DTB

Date: November 15, 2007
Order No.: P-B-42.46/27e
Supersedes: P-B-42.46/27d dated June 16, 2004
Group: 42

SUBJECT: Model 211.026/056/065/070/076/082/083/087/256/265/276/282/283/287
Model 219.375/376
Model Year 2003 – 2006
Buzzing Noise During Pressure Buildup from SBC System

Figure 1

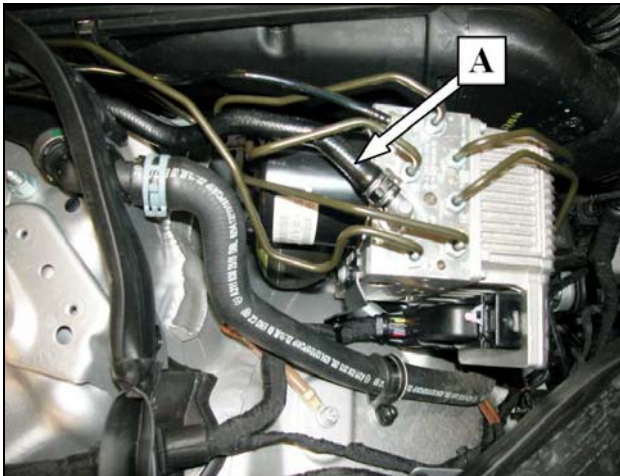
i **Note:** The single suction damper (A000 431 04 77) is being replaced by a suction hose with integral double suction dampers.

- Replace the suction hose (Figure 1, A) by unfastening the hose clamp at the connection between the suction hose and suction line (Figure 2) and carefully pull the suction hose off the suction line using a mounting wedge.

- Push the new suction hose with integral dampers onto the suction line attached to the vehicle and secure it with a new hose clamp.
- Check for leaks at the hose connections.
